SUPPLEMENTAL INVESTIGATION WORK PLAN

Former Framatome Facility
Lots 1 & 2 - 80 Wampus Lane
Milford, Connecticut

***Re: Responses to DEP & EPA December 2, 2008 Letter
Former Framatome Facility
Lots 1 & 2, 80 Wampus Lane, Milford, Connecticut***

Figure 3 - Proposed AOC-2 Soil Sample Locations
 Former Framatome Facility
 80 Wampus Lane, Milford, CT

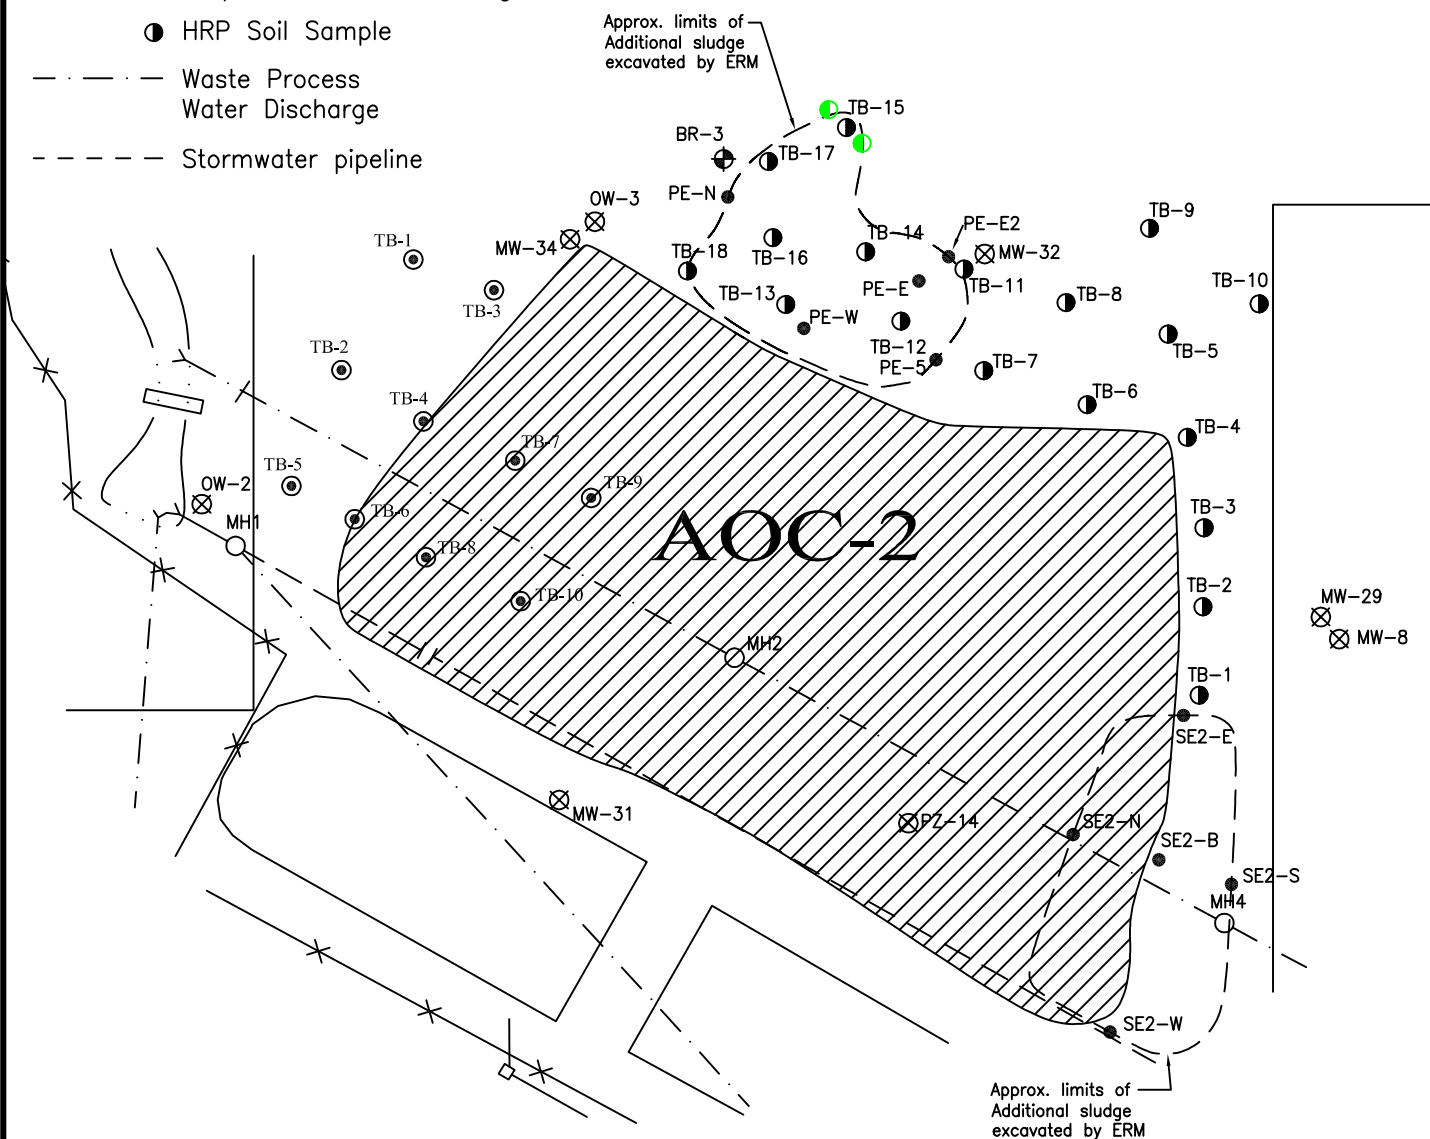
4. *Section 3.1.2 states that AOC-2 was fully investigated and successfully Remediated in 2002 by WMA's contractor, ERM, and that no other remedial activities are required to satisfy the CT RSRs or RCRA Corrective Action. The August 2002 Annual Summary Report (the 2002 Report) noted that in 1997, 3,700 tons of sludge and soil were excavated from the landfill by FCI. However, two soil samples at the base of the excavation contained PCE at levels exceeding the CT RSR Industrial/Commercial Direct Exposure Criteria (I/C DEC). The 2002 Report does not cite the depth or location of these samples, so it is unclear whether the PCE-contaminated soil was excavated as part of the excavation in 2002. Please provide a figure showing the location of these samples and a table providing sample depths and constituent concentrations detected. Please also specify whether the locations of these samples was included in previous soil removal. If these locations have been remediated, please provide relevant details. If not, please outline WMA's intended approach for compliance with the I/C DEC for this area.*

Elevated concentrations of TPH (>I/C DEC) in TB-15, collected in 1998, were found at 4-6 foot depth. However, the 2002 excavation in this area reportedly only extended to a depth of 3-4 feet. Samples were not collected at the base of the excavation because it was below the seasonal low water table. In addition, at post-excavation sample PE-E, total chromium was detected at 154 mg/kg, in excess of the I/C DEC for hexavalent chromium. No Results for hexavalent chromium are presented for this location. Please outline WMA's intended approach for compliance with the CT RSRs at these locations and any other where remaining soil exceeds CT RSR default criteria.

The area around HRP soil boring TB-15 was included within the supplemental AOC-2 remedial excavation work by ERM. This excavation removed soil and sludge down to approximately 1 foot below the water table, where the remaining soil exhibited no visual, olfactory or field screening evidence of residual impacts. Post-excavation samples were collected from within the supplemental excavation area, focusing on the side walls of the excavation due to the shallow groundwater table. Since HRP sampled TB-15 in 1997, the grade has been lowered, but, based on field observations and screening data, it is believed that the 4-6 foot horizon in this sample corresponds with the bottom of the excavation performed by ERM and has therefore been removed. Absent the hexavalent chromium issue raised in the comment, all endpoint soil data indicated compliance with the RSRs. ERM will collect additional soil samples in this area for hexavalent chromium and TPH analysis, the scope of which is described in the attached Work Plan.

ERM will advance two shallow soil borings via hand auger and collect two additional soil samples in the location of the previously completed TB-15, where HRP collected a soil sample from a reported depth of 4-6 feet that contained levels of total petroleum-hydrocarbons in excess of the applicable RSR numerical criteria. These boring locations are shown on [Figure 3](#).

One soil sample will be collected from each of the two proposed boring locations. The actual depth of these samples will be determined in the field, as the grade of this portion of the site has been lowered since HRP collected their sample. The borings will extend through the imported fill material emplaced after the excavation conducted by ERM. The samples will be collected from the upper native soil immediately below the fill material. The samples will be analyzed for TPH using the CT ETPH Method, total chromium using Method 6010 and hexavalent chromium using Method 7196.

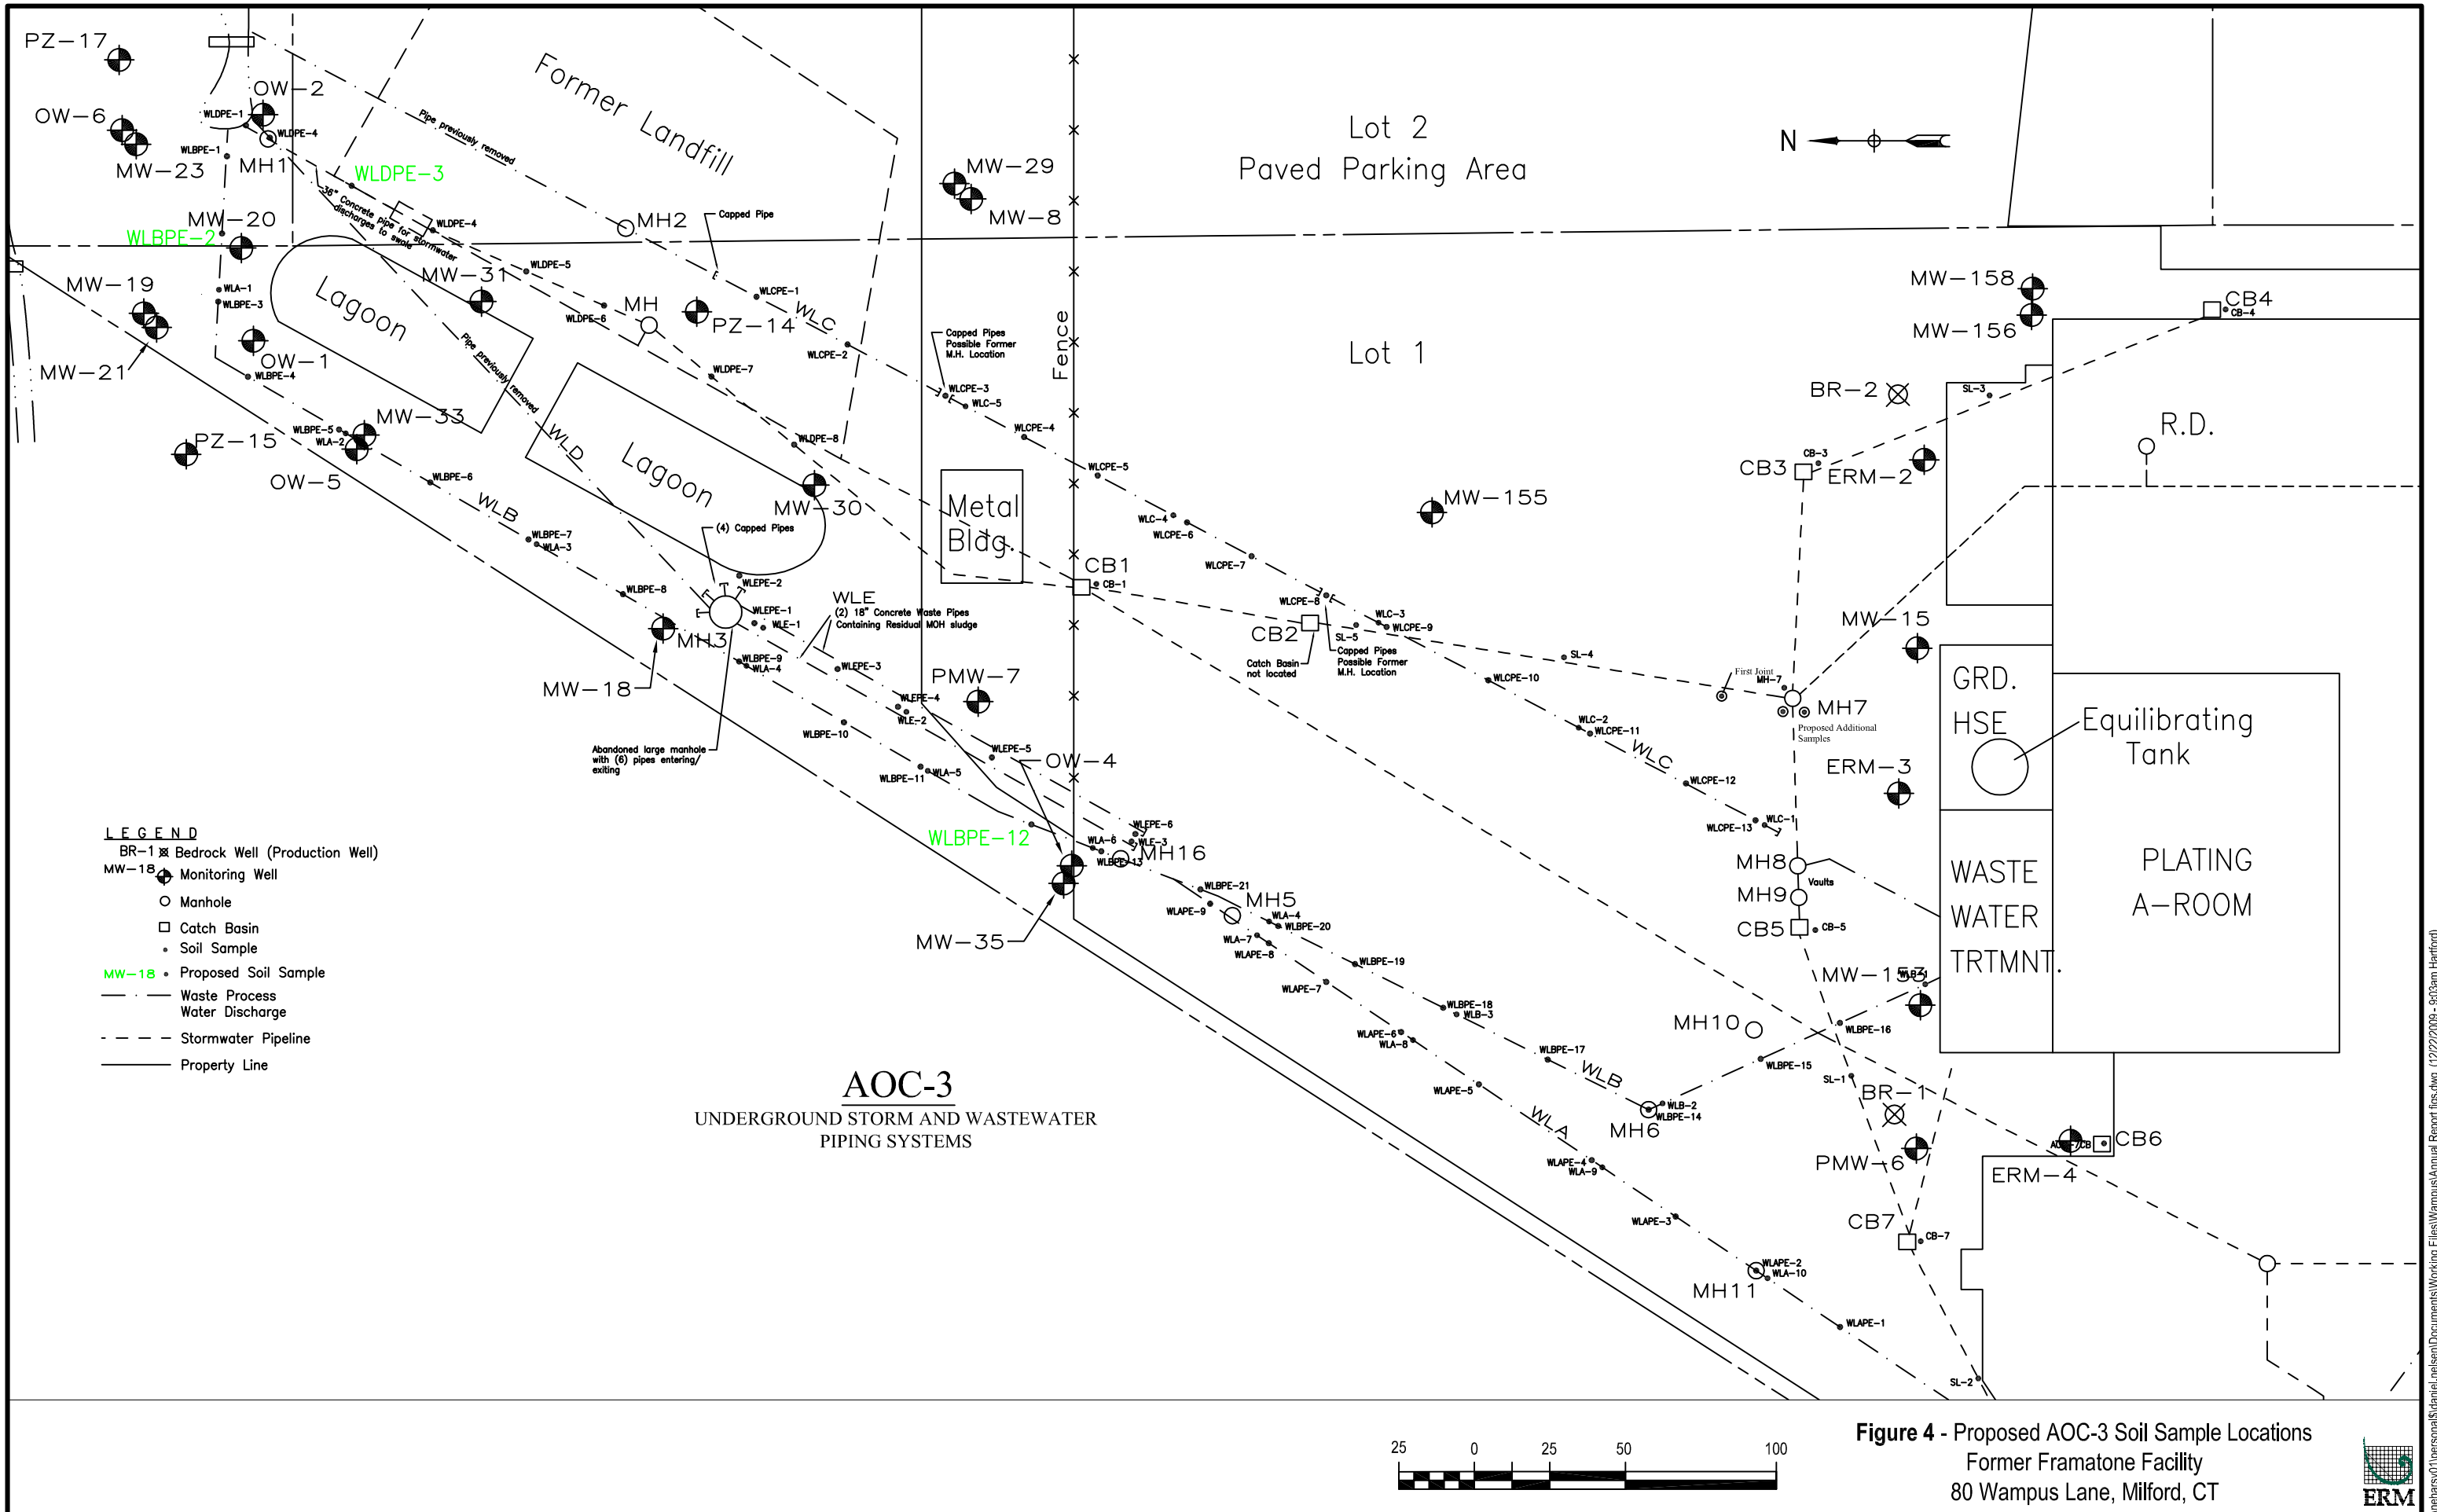
8. *Section 3.2.1 states that the MH-7 area was the only portion of AOC 3 not remediated in 2002. However, results of prior investigation show other potential CT RSR exceedances. Sample WLDPE-3 contained TPH at levels exceeding the I/C DEC. In addition, samples WLBPE-12 and WLAPE-2 contained total chromium in excess of the I/C DEC criterion for hexavalent chromium, but results of confirmatory analysis for hexavalent chromium are not presented. Please outline WMA's intended approach for demonstrating compliance with the CT RSRs at these locations.*

In the case of post-excavation sample WLDPE-3, ERM plans to resample this soil to evaluate whether the concentration of petroleum has dropped below the I/C DEC over the past eight years. If the TPH concentration in soil in this area is below the I/C DEC, then the issue will be addressed through the placement of the ELUR restricting Residential uses for the Site. If the TPH concentration in soil is still above the I/C DEC, then ERM will collect additional soil samples in the release area and evaluate the use of the 95% upper confidence to demonstrate compliance with the I/C DEC. Based on the comparative costs of the above

options, ERM may opt to remove this small amount of residual TPH-impacted soil, if present, without the aforementioned additional evaluation. ERM will collect additional samples in the area of WLAPE-2 and WLBPE-12 for hexavalent chromium analysis, which is detailed in the attached Work Plan.

Sample WLD PE-3 originated from the far northern end to waste line D, 60 feet south of the former discharge point to the drainage swale (See [Figure 4](#)). The sample originated from a depth of 3.5 feet (bottom of the pipe). ERM will resample the soil in this area to evaluate whether the concentration of TPH (4,000 mg/kg in 2001) has dropped below the I/C DEC of 2,500 mg/kg over the past eight years. One soil boring will be advanced via hand auger, from the same location as the original sample. One sample will be collected at the same depth as the prior sample (3.5 feet below grade) and analyzed for TPH via the CT ETPH Method.

WLAPE-2 and WLBPE-12 were collected by ERM to determine the condition of the soil immediately below the removed waste lines at a depth of 4 feet below the ground surface (see [Figure 4](#)). ERM will recollect these two soil samples using a hand auger and analyze them for total chromium using Method 6010 and hexavalent chromium using Method 7196.
